<b>DOCKETED</b>	
<b>Docket Number:</b>	08-AFC-07C
<b>Project Title:</b>	GWF Tracy (Compliance)
<b>TN #:</b>	239819
<b>Document Title:</b>	Petition to Amend (PTA) the Commission Decision
<b>Description:</b>	Petition to Amend (PTA) the Commission Decision to install and operate the wet compression system for the existing combustion turbines to augment power production on hot days.
<b>Filer:</b>	Anwar Ali
<b>Organization:</b>	MRP San Joaquin Energy LLC
<b>Submitter Role:</b>	Applicant
<b>Submission Date:</b>	9/23/2021 10:25:47 AM
<b>Docketed Date:</b>	9/23/2021

Subject: Petition to Amend Package for Tracy Combined Cycle Power Plant –  
Wet Compression Project

**Petition for Post-Certification Amendment  
Wet Compression Project**

**MRP San Joaquin Energy, LLC  
Tracy Combined-Cycle Power Plant  
08-AFC-07**

**Figure 1: Wet Compression Diagram**

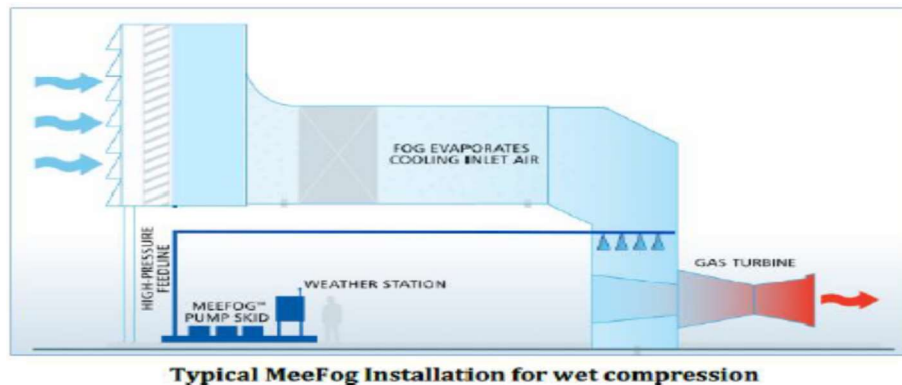
Wet Compression is a water-based injection system installed in the gas turbine inlet and is used to provide additional power output by creating an increased mass flow similar to evaporation coolers or fogging (see Figure 1). Wet Compression is accomplished by spraying more fog than is required to fully saturate the inlet air. The excess fog droplets are carried into the gas turbine compressor where they evaporate and produce an intercooling effect. The injected water

reduces the temperature of the air prior to compression, which reduces the work required to be performed by the compressor. Nearly 50-65 percent of the turbine output is used to drive the compressor; therefore, a reduction in the workload to the compressors results in a net increase in the power available. The wet compression system also results in a reduction in compressor discharge temperature which in turn results in lower combustion temperature and lower turbine exhaust temperature for the same fuel flow rate. Turbine output is controlled by turbine exhaust temperature so that for the same design controlling exhaust temperature, additional mass flow of fuel and water can be added. This results in an increase in power from the combustion turbine. In addition to the increase in generation and improvement in heat rates, the wet compression system is expected to result in no significant changes in NOx emissions from the combustion turbine which will be fully controlled within limits by the SCR system.

Figure 4: Wet Compression Project Component Locations

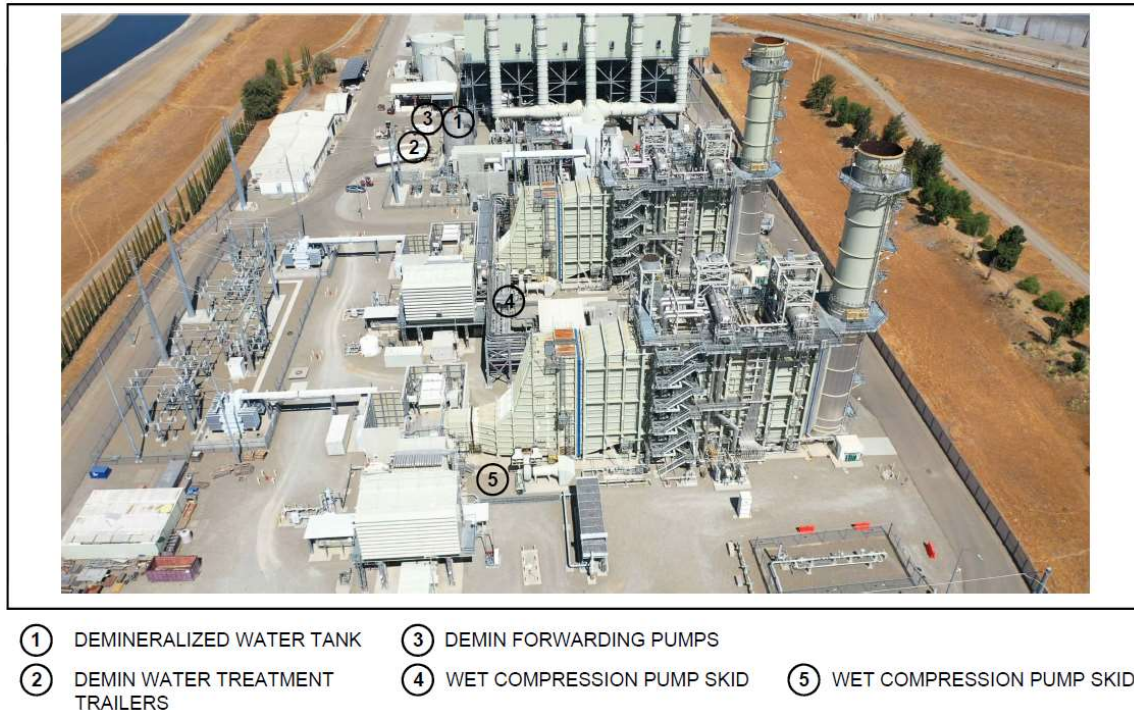
The Wet Compression pump skid enclosures will be located adjacent to the CTGs (see Figure 4).

The trailer mounted demineralizer units are located on a paved area as shown on Figures 4 and 5. The demineralizer units are self-contained and do not require onsite discharge. Once the units are spent, they are removed and replaced by another trailer mounted unit. There is an existing 125,000-gallon demineralized water tank at the TCCP (see Figure 4), and additional storage is not expected to be required for the Wet Compression Project.

**Figure 1: Wet Compression Diagram**

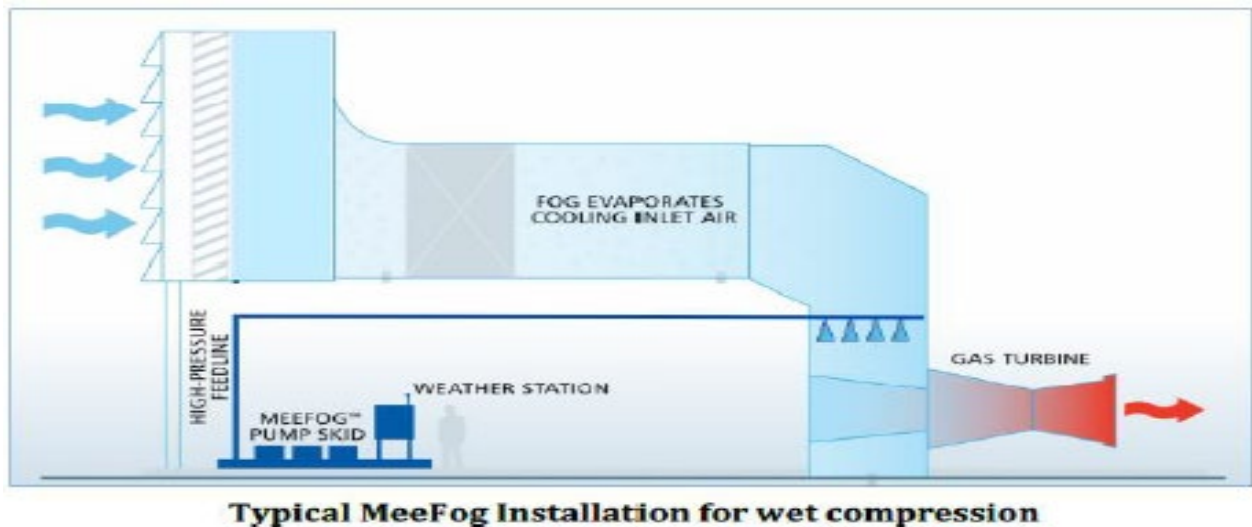
Wet Compression is a water-based injection system installed in the gas turbine inlet and is used to provide additional power output by creating an increased mass flow similar to evaporation coolers or fogging. Wet Compression is accomplished by spraying more fog than is required to fully saturate the inlet air. The excess fog droplets are carried into the gas turbine compressor where they evaporate and produce an intercooling effect. The injected water reduces the temperature of the air prior to compression, which reduces the work required to be performed by the compressor. Nearly 50-65% of the turbine output is used to drive the compressor; therefore, a reduction in the workload to the compressors results in a net increase in the power available. The wet compression system also results in a reduction in compressor discharge temperature which in turn results in lower combustion temperature and lower turbine exhaust temperature for the same fuel flow rate. Turbine output is controlled by turbine exhaust temperature so that for the same design controlling exhaust temperature, additional mass flow of fuel and water can be added. This results in an increase in power from the combustion turbine. In addition to the increase in generation and improvement in heat rates, the wet compression system is expected to result in slight reductions in NO<sub>x</sub> emissions from the combustion turbine.

The cooling effect can only be accomplished when ambient temperatures exceed 60 °F. Wet compression would typically operate at temperatures greater than exceed 90 °F, when the plant is de-rated due to ambient conditions. Based on modelling by the manufacturer, TPP expects wet compression to increase the output by as much as 12 MW per gas turbine during warm weather, mitigating the thermal ambient de-rate. Rated capacity of the unit is not expected to change, but by avoiding de-rate during high heat events, the project will better enable the TPP to contribute to reliability needs during peak conditions in the summer. The system includes a skid of high-
